CITY PLANNING COMMISSION

- APPLICATION:**
1. Environmental Determination
  2. Amendment of the 1976 South Natomas Community Plan to reduce a designated high school site from 40 acres to 25 acres
  3. Rezone 13.5± vacant acres from Single Family (R-1) to Townhouse (R-1A) and a portion of the school site from Single Family (R-1) to Agricultural (A)
  4. Tentative Map (P83-384, Bridge Creek)
  5. Special Permit for development of 107 zero-lot line, single-family units (Section 2-B-3a, Zoning Ordinance)
  6. Subdivision Modification to reduce residential street right-of-way from 44 feet to 40 feet (Section 40.309, 40.310, Subdivision Ordinance)

**LOCATION:** Northwest corner of Bannon Creek Drive and Truxel Road

**PROPOSAL:** The applicant is requesting the necessary entitlements to develop 107 zero-lot line, single family units.

## TENTATIVE MAP BRIDGECREEK

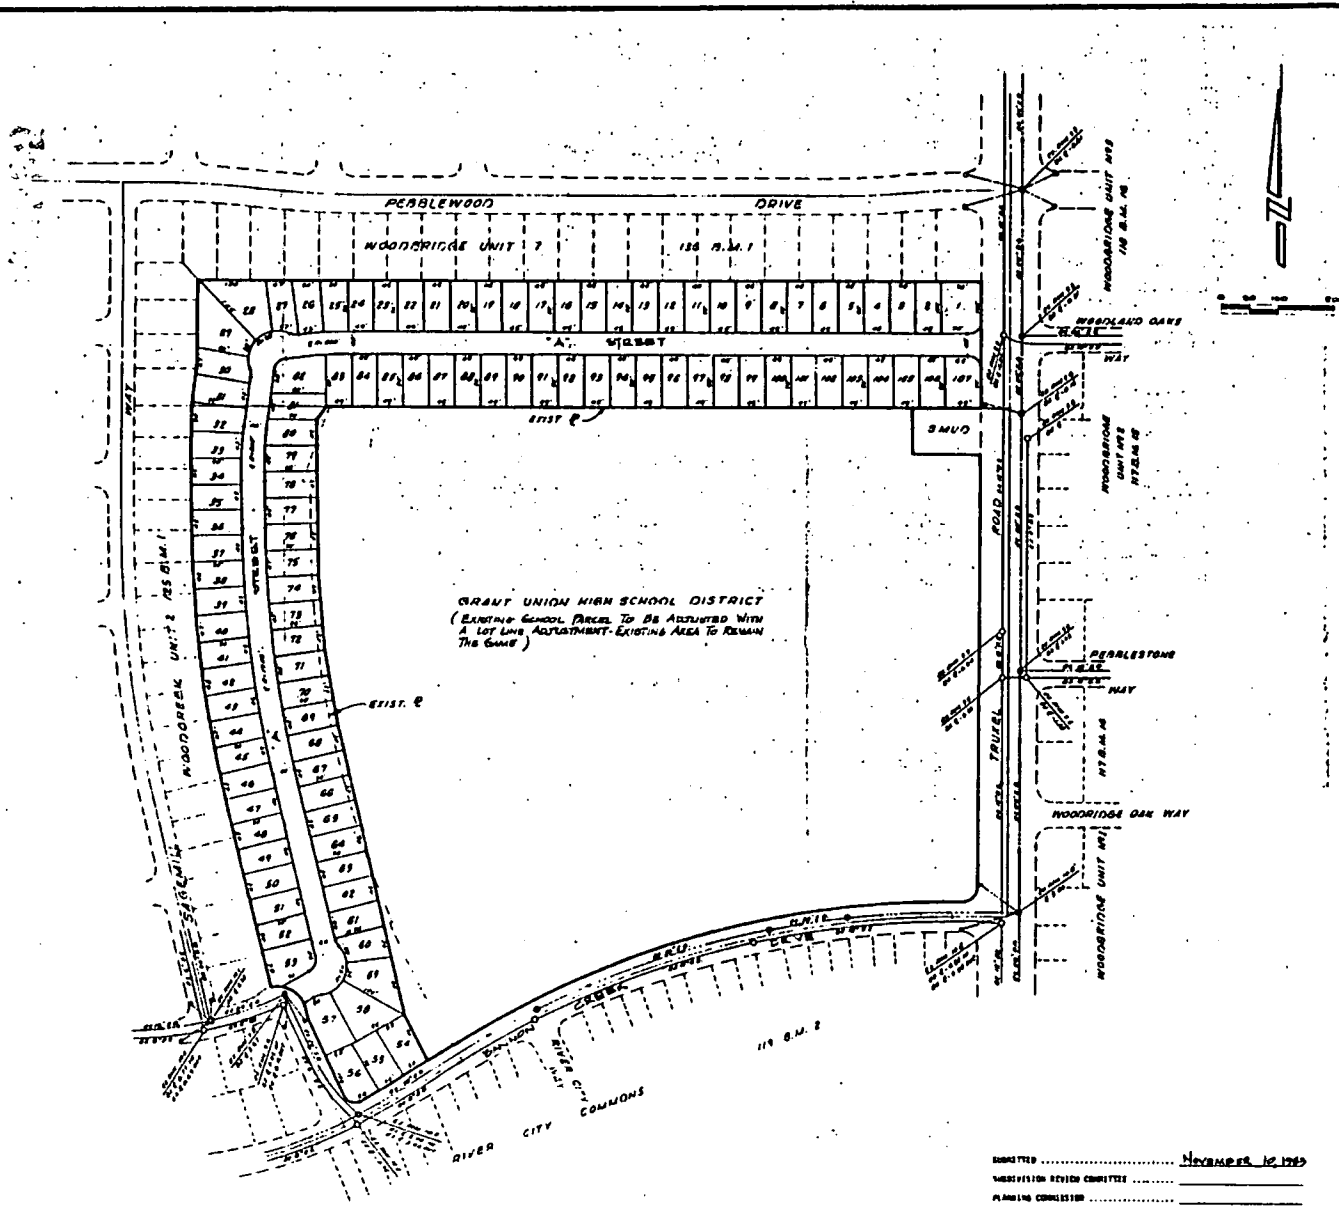
1. The subject site consists of irregularly shaped property remnants. The overall depth prohibits standard residential lot depths and street right-of-way widths. Further, acquisition of land to accommodate single family development is prohibitive since the school district requires all 25 acres of land it now owns. Staff and the Subdivision Review Committee recommend approval of the subdivision modification to reduce the standard street right-of-way width. The applicant will construct the street to 30-foot paving, curbs, gutters and sidewalks and provide a 14.5 foot wide public utilities easement. The additional easement will accommodate city utilities usually placed in the strip 2' back of sidewalk.

5. The school site is a portion of the current request. The Subdivision Review Committee has, therefore, recommended that street frontage improvements be extended along the school site to Bannon Creek Drive. Staff concurs with this requirement. In addition, to assure uninterrupted street improvements the S.R.C. has required off-site improvements along the SMUD frontage on Truxel Road.

6. The overall project achieves a 54-percent north/south orientation to be consistent with the 80-percent north/south lot orientation requirement of the General Plan. The map has been conditioned so that individual building plans will be reviewed for solar access at the time building permits are issued.

- a. Provide standard subdivision improvements, including along the Truxel Road frontage, pursuant to Section 40.811 of the City Code;
- b. Prepare a sewer and drainage study for the review and approval of the City Engineer;
- c. Pay off existing assessments or file the necessary segregation requests and fees to segregate existing assessments;
- d. Pursuant to City Code Section 40.1302 (Parkland Dedication), the applicant shall submit to the City an appraisal of the property to be subdivided and pay the required parkland dedication in-lieu fees. The appraisal shall be dated not more than 90 days prior to the filing of the final map;

- h. Provide 40 foot wide road right-of-way. Construct streets to 44 feet wide road standard (30 ft. of paving, curbs, gutters and sidewalks);
- i. Provide a 14.5 foot wide public utilities easement adjacent to the road right-of-way along street frontages.

Schematic Plan

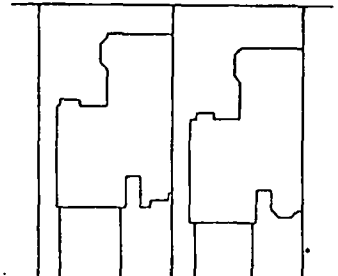
4. The building envelop in the proposed schematic plan indicates 20 foot front yard setbacks, 10 foot rear yards, and one 5 foot side yard. These are minimum setbacks required to construct the proposed units. The applicant intends to vary front yard setbacks between 20 and 30 feet. Staff notes the minimum driveway length is 20 feet. Staff requests that rear and side yard setbacks not be reduced beyond 10 feet and 5 feet respectively. Site plans should be reviewed by the Planning Department prior to issuance of building permits. Outdoor living area will be primarily located in the garden court area created by the structural configuration. Staff believes that adequate elevation, material and setback variety is proposed for a varied and interesting streetscape. Furthermore, adequate outdoor living area is provided with the garden patio area and that the outdoor living area corresponds to the indoor living area.

- 1. The applicant shall submit two additional floor plans and 6 additional elevations for review by the Planning Director prior to issuance of building permits. Said plans shall indicate:
  - a. Compatibility with plans submitted.
  - b. Variety of building materials.
  - c. Variety of element (garage doors, doors, windows, etc.) treatments.
  - d. One and two story unit mixture.
  - e. Variety of roofline treatments.
  - f. Shake roofs or similar material.
- 2. The applicant shall submit individual site plans for review and approval of the Planning Director prior to issuance of building permits indicating staggered setbacks. In no case shall setbacks be reduced below:
  - a. 20 feet front.
  - b. 5 feet one side (0 on the opposite).
  - c. 10 feet rear yard.
